Product Change Notification

PCN-PCC-6887-2021

Business Unit	Product Line Code	Type of Change	Action	Date of Issue
PCC - PCB Connectors	AAB	Product Change Notification	Notify Distributors and Field	6/14/2021

Description for Product Change Notification

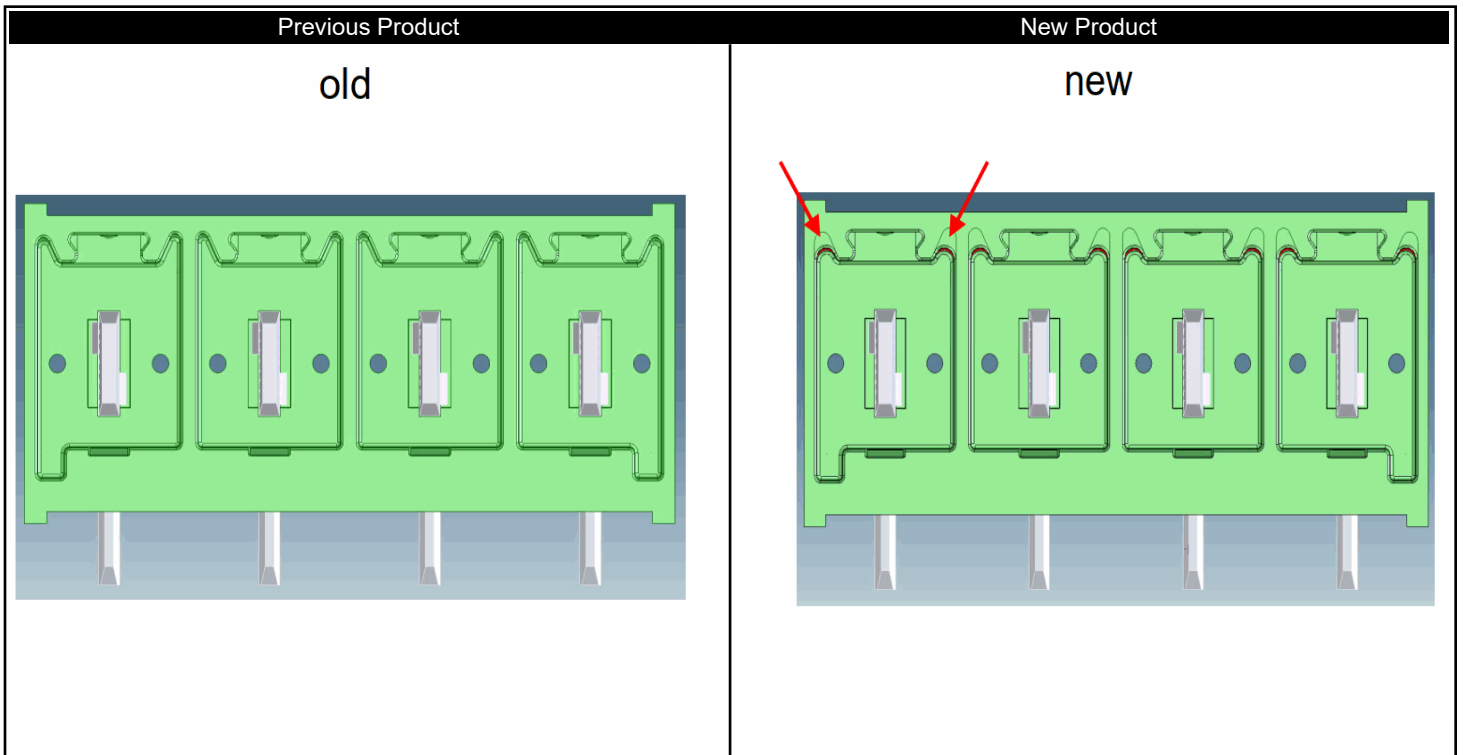
To further improve this product offering, the recesses on the left and right (red arrows in the attached figure) next to the coding grooves will be reduced. This will provide improved protection against mismatching. The external dimensions and electrical data remain unchanged. All combinable counterparts can continue to be used without limitation.
